E8357A-02C**S E R V I C E****N O T E**Supersedes:
E8357A-02B**E8357A PNA Series RF Network Analyzers**

Serial Numbers: 00000000 thru 46999999

Many of the Front Panel Interface (FPI) boards which were installed per Service Note E8357A-02B need to be modified or replaced because the RPG shaft can disconnect, and the front panel keyboard and RPG can respond intermittently upon boot up.

Figure 1

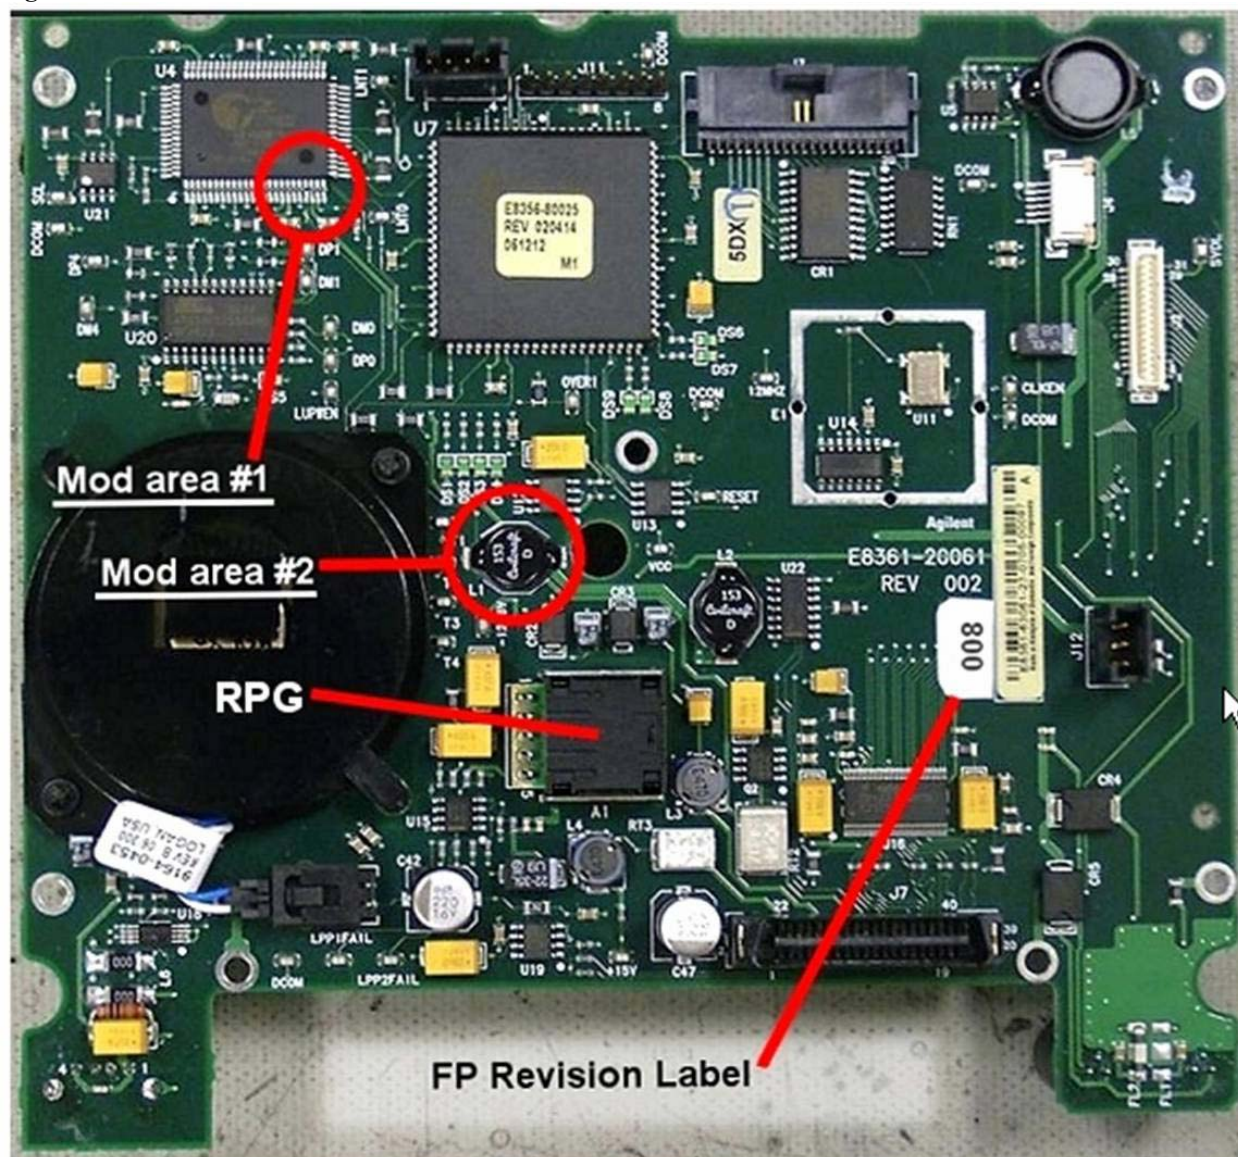
Refer to Figure 1 for the two modification areas to be addressed. Note that while this picture happens to show the FPI board completely removed from the front frame assembly, this is not necessary to perform the required modifications.

- Modification #1 consists of shorting two pins of U4 together with a small amount of solder.
- Modification #2 consist of removing L1.

Unsolder and completely remove the black surface mount inductor L1 from the front panel assembly board. This is no longer needed and can be discarded.

Figure 2

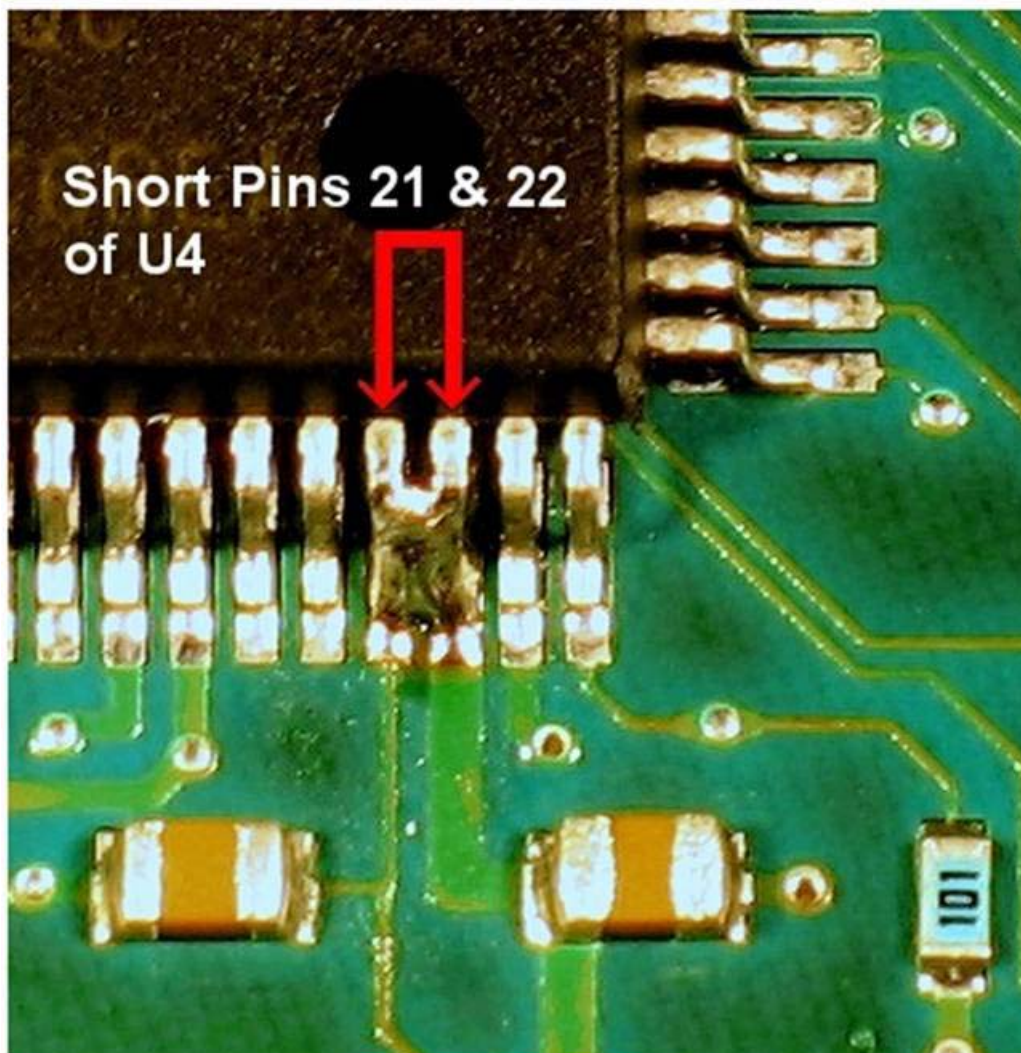
Carefully solder pins 21 and 22 together on U4. Refer to Figure 2 for the exact location. Use care so that no other pins are shorted. Use of a very fine tip soldering iron is recommended and a large work-task magnifying glass is very helpful.
